DNAworkshop
DYKE NELSON ARCHITECTURE
235 South 14th Street, Baton Rouge, Louisiana 70802 [225] 224 3363 DNA-Workshop.com

ADDENDUM 4

7/18/2025
Capstone at Covington Place
24-064

The Banyan Foundation

1 LIFE SAFETY - THIRD FLOOR
1" = 20'-0"

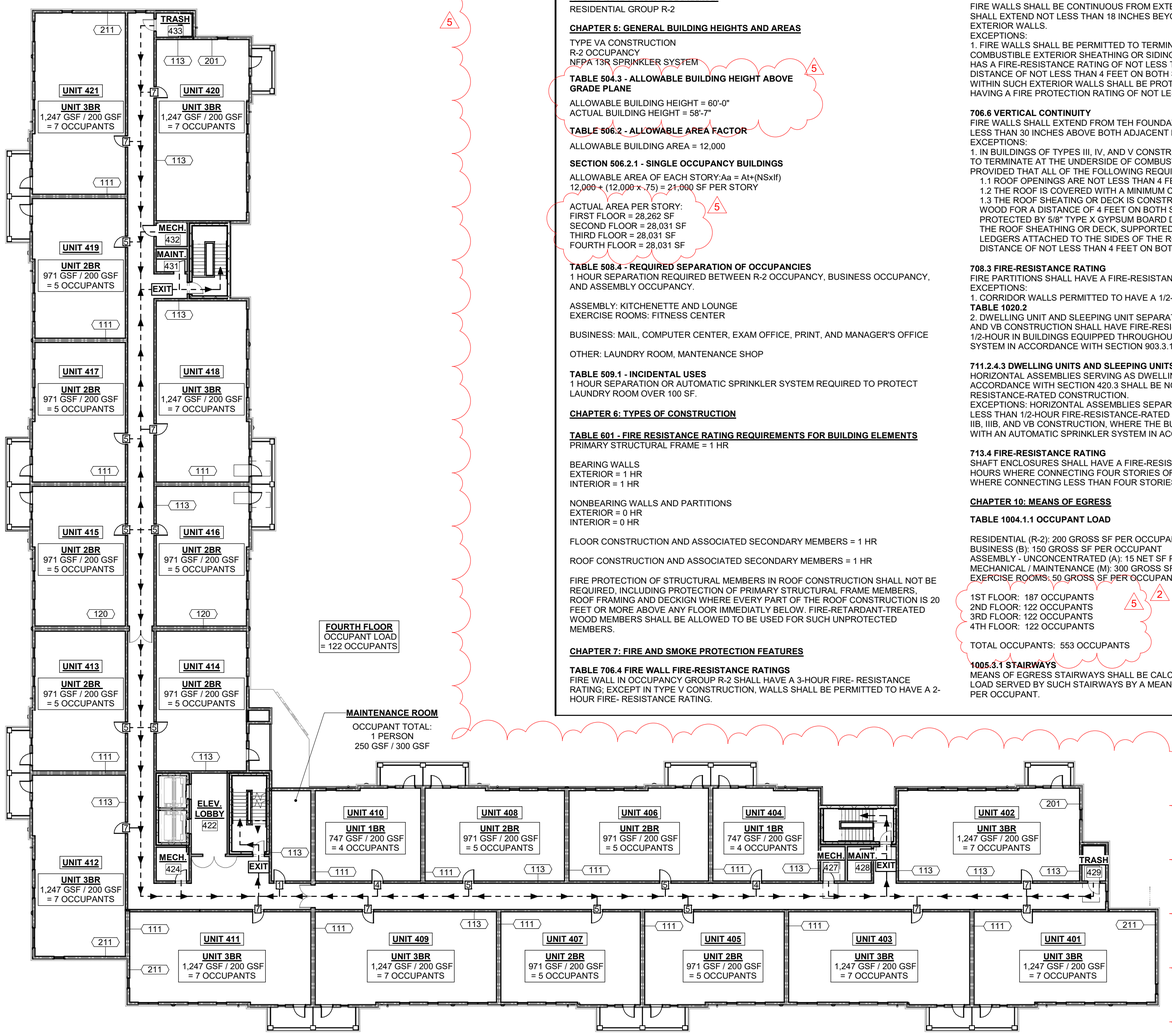
Add 1.3 LS100 to LS101 – Life Safety Plans
- Note the addition of wall tags.
- Note change to Actual Building Height.
- Note the updated Actual Area Per Story of each floor.
- Note the updated gross square footage of each unit.
- Note the updated occupant loads.

SHEET NUMBER C-1

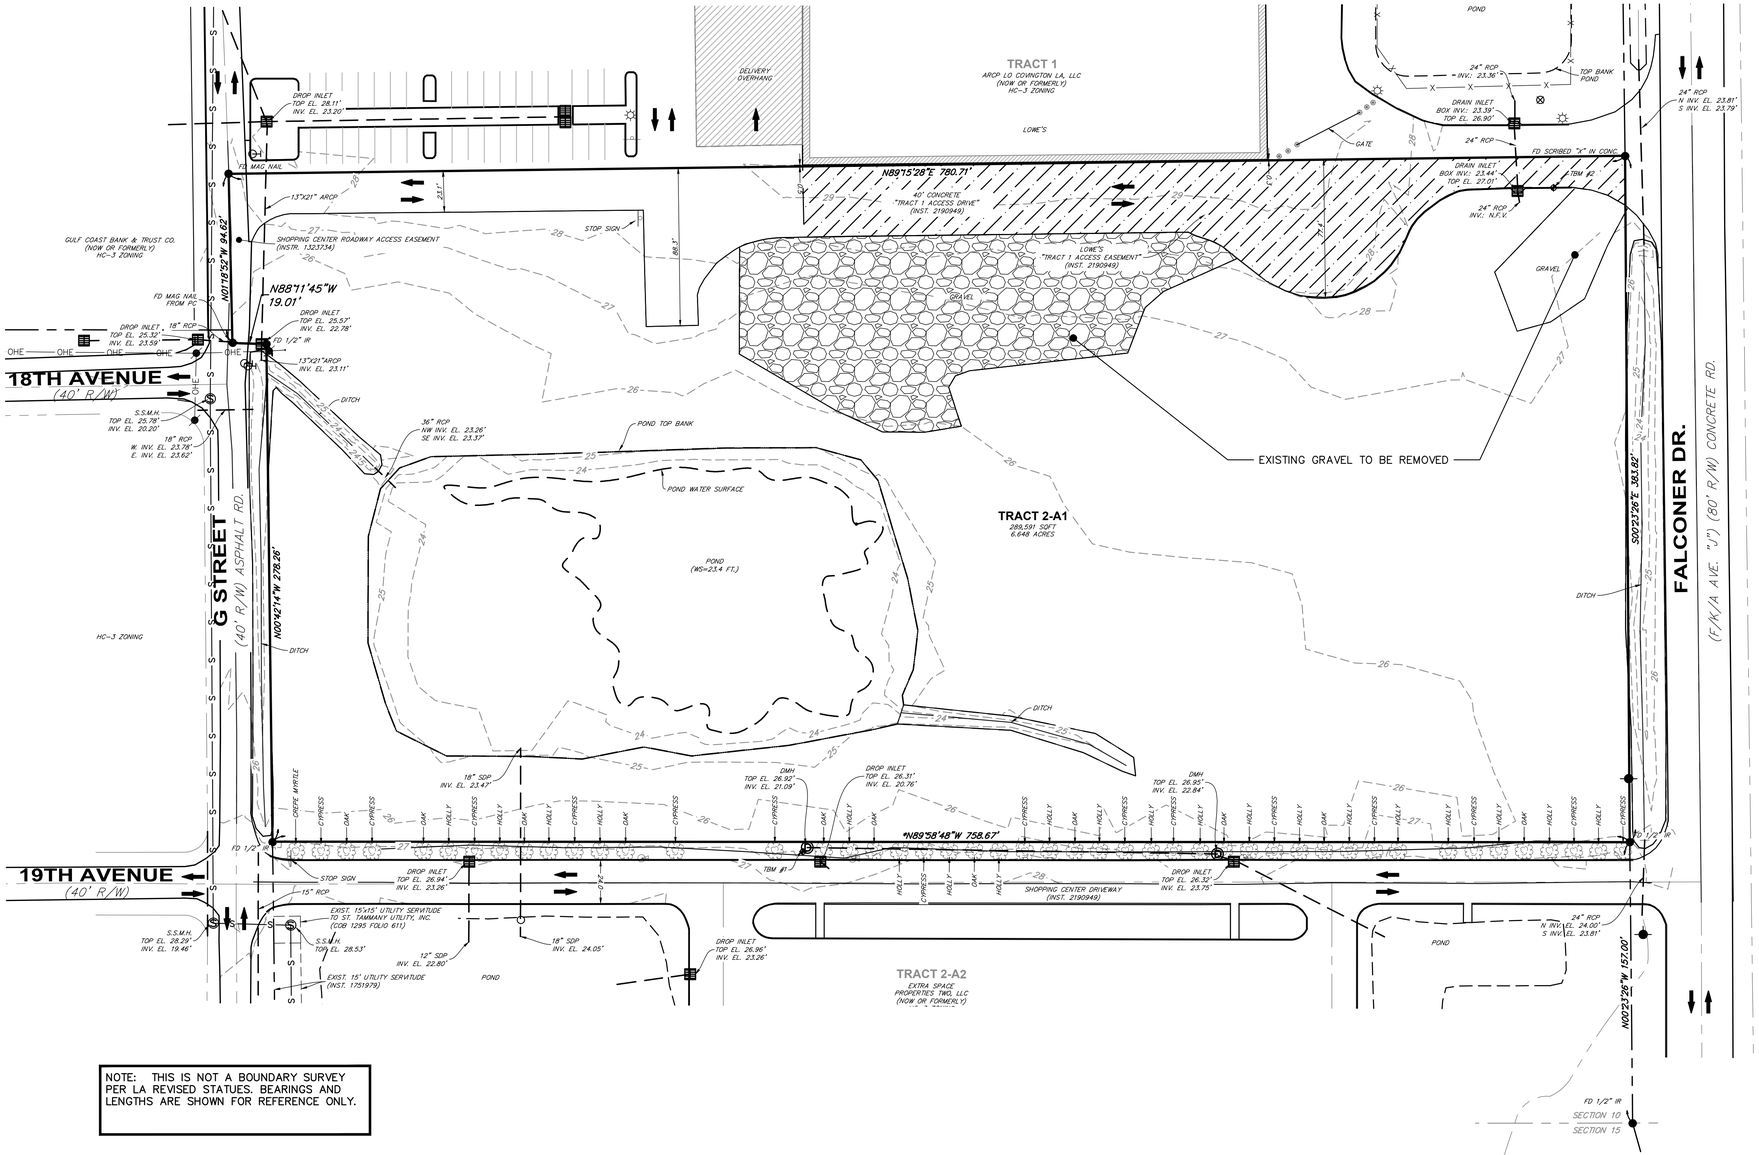
Add 1.4 **C-1 to C-13 – Demolition Plan**

- Note the deletion of 30 parking spaces to reduce the overall total to 130 parking spaces, which includes revised dumpster enclosure locations.
- Note the reduction in ornamental fencing.
- Note the deletion of the EV charging stations.
- Note the deletion of the basketball court and all associated equipment from the project.
- Note the deletion of the first-floor trash rooms and the addition of the brick-fenced-in dumpster locations at the base of the trash chutes.
- Note the addition of outdoor seating areas.

1 ARCHITECTURAL SITE PLAN
1" = 30'-0"

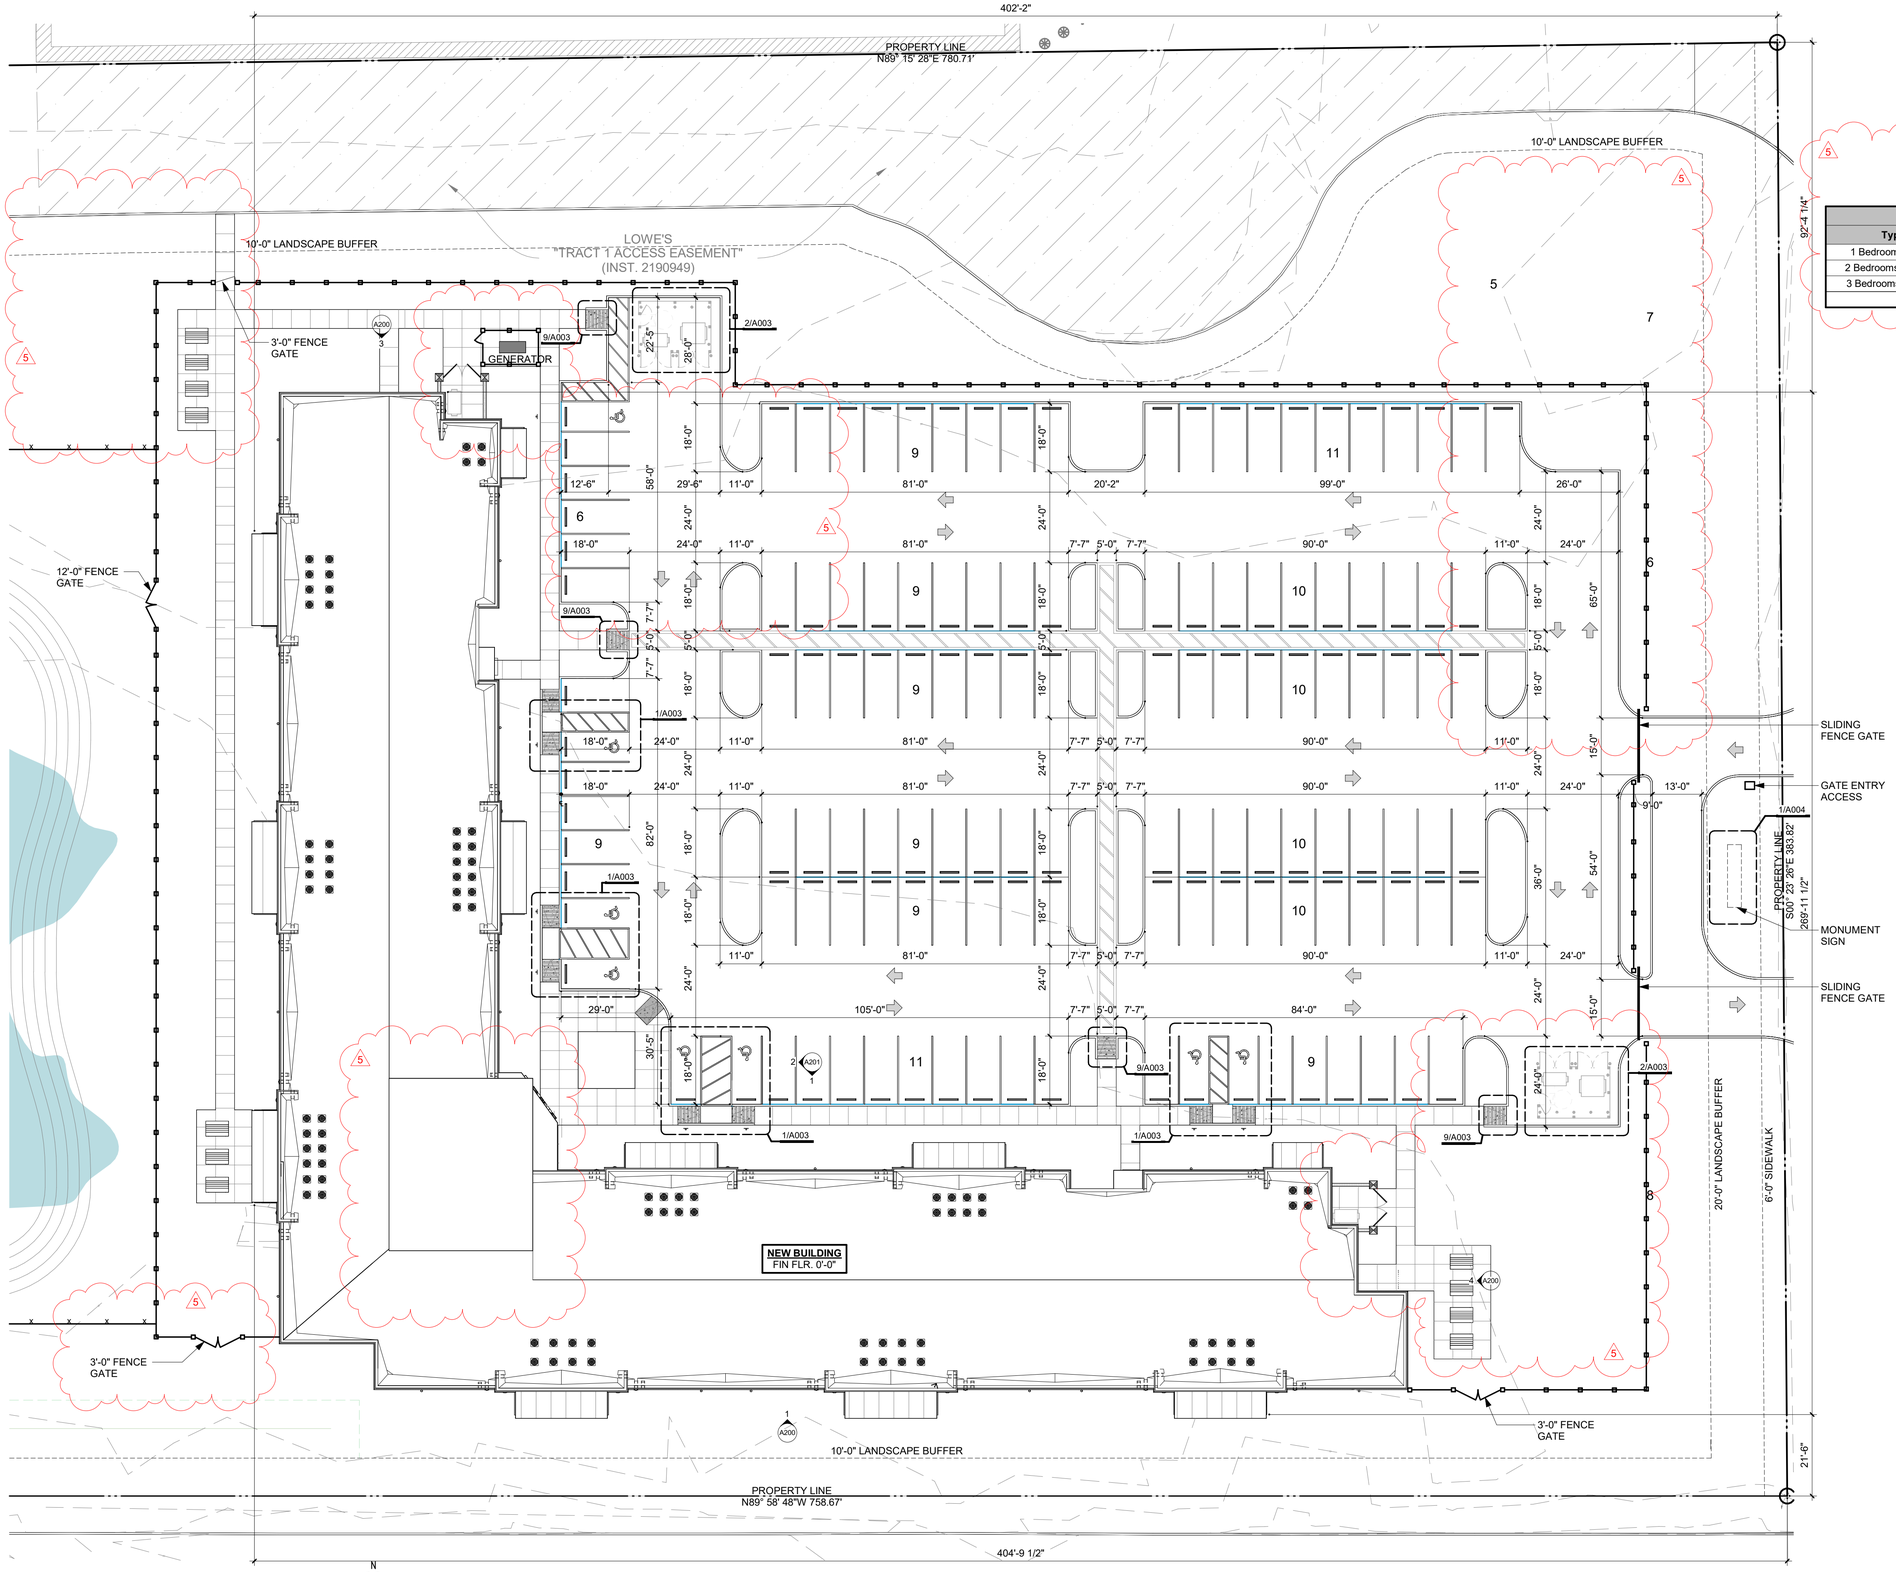
Add 1.5 **A001 to A004 – Site Plan and Site Amenities**

- Note the deletion of 30 parking spaces to reduce the overall total to 130 parking spaces, which includes revised dumpster enclosure locations.
- Note the reduction in ornamental fencing.
- Note the deletion of the EV charging stations.
- Note the deletion of the basketball court and all associated equipment from the project.
- Note the deletion of the first-floor trash rooms and the addition of the brick-fenced-in dumpster locations at the base of the trash chutes. Brick dumpster enclosure elevation added to A004.
- Note the addition of outdoor seating areas.
- Note the addition of park bench details to A004.

A101

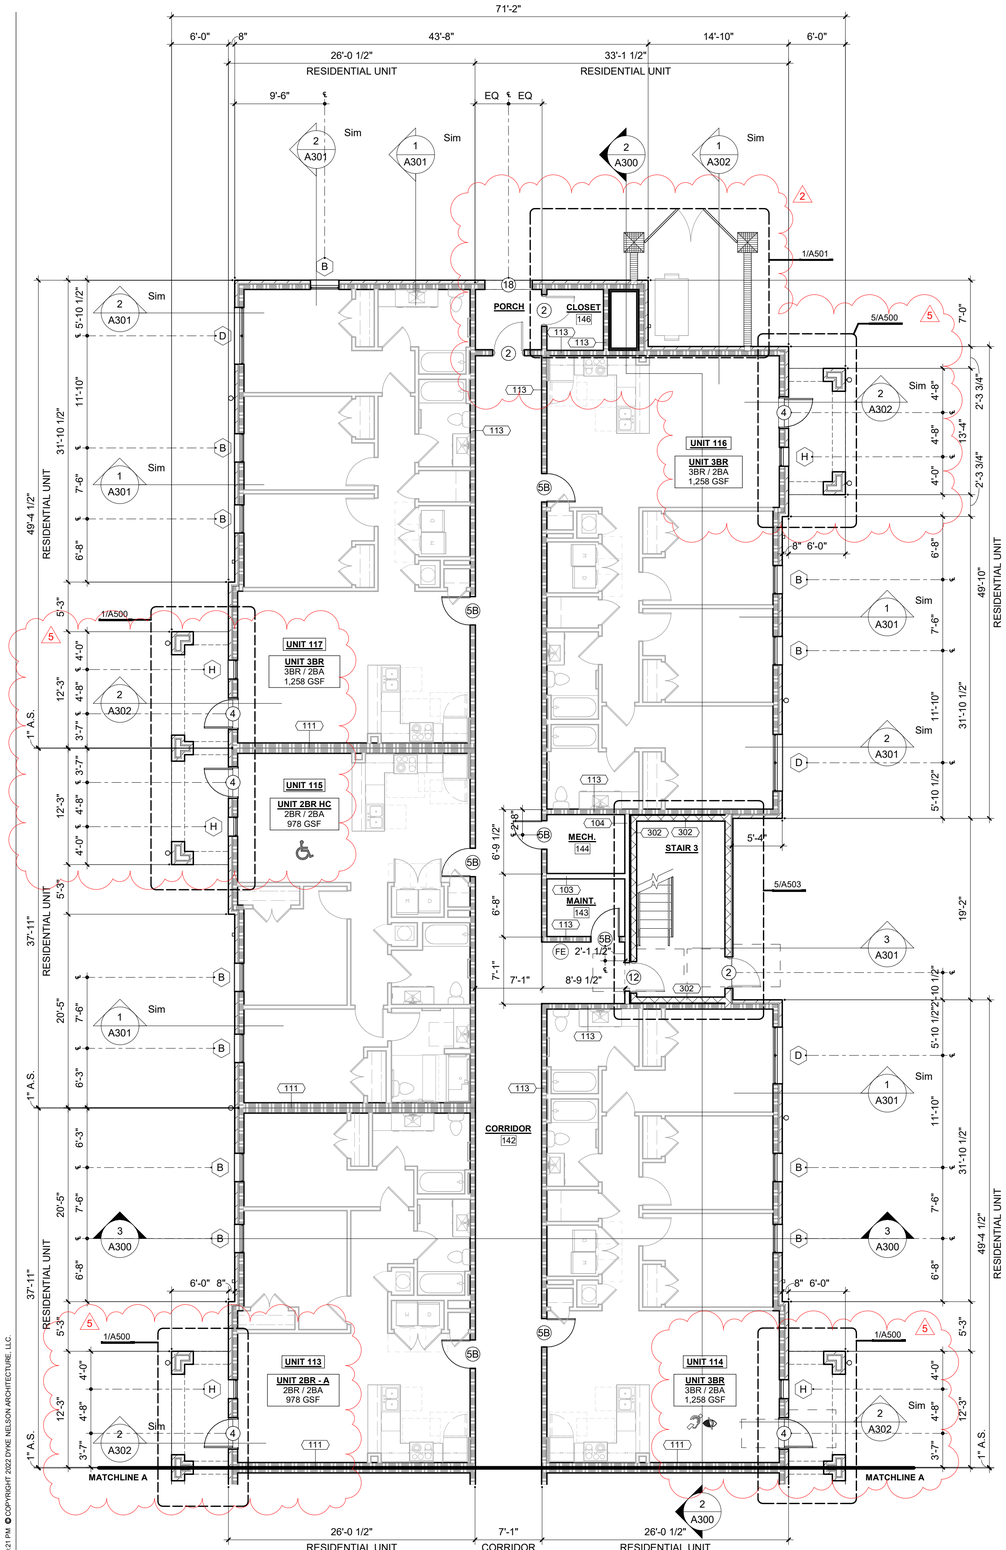
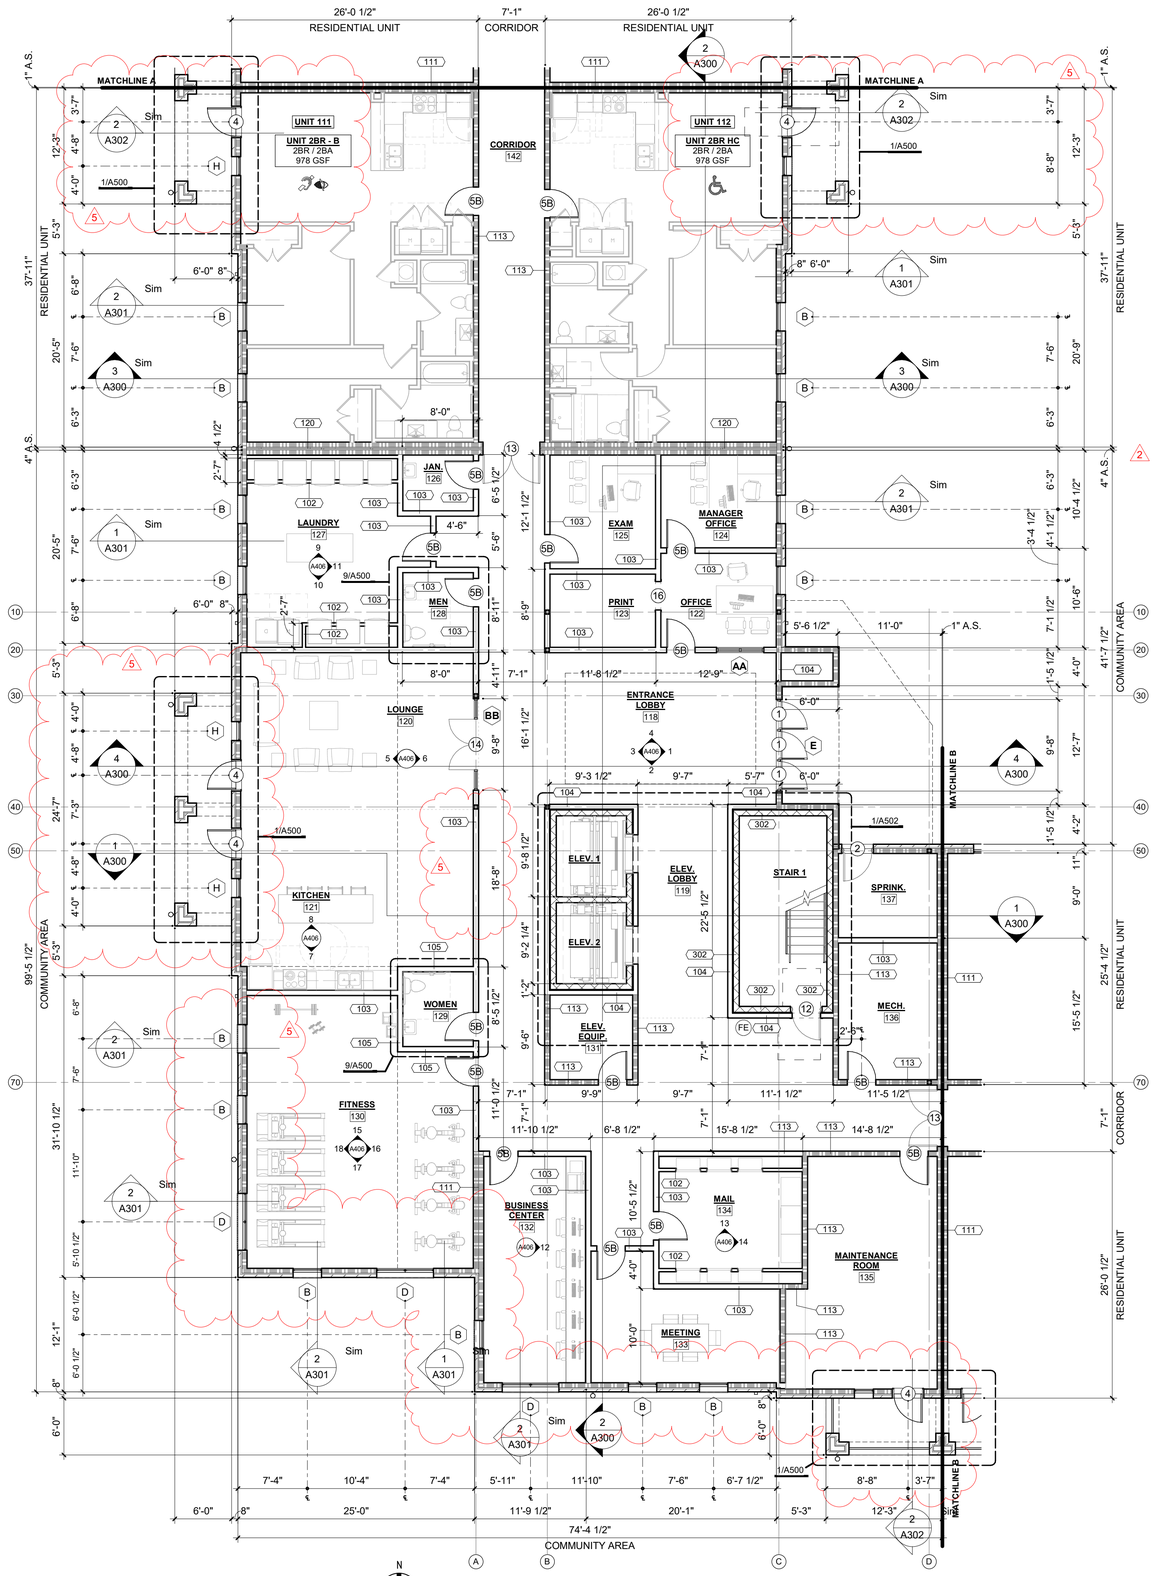
Add 1.6 **A100 to A111 – Building Floor Plans**

- Note changes from CMU walls to wood-framed walls at all trash chute locations.
- Note revised side entry porches at the end of Corridor 138 and Corridor 142 on the first floor.
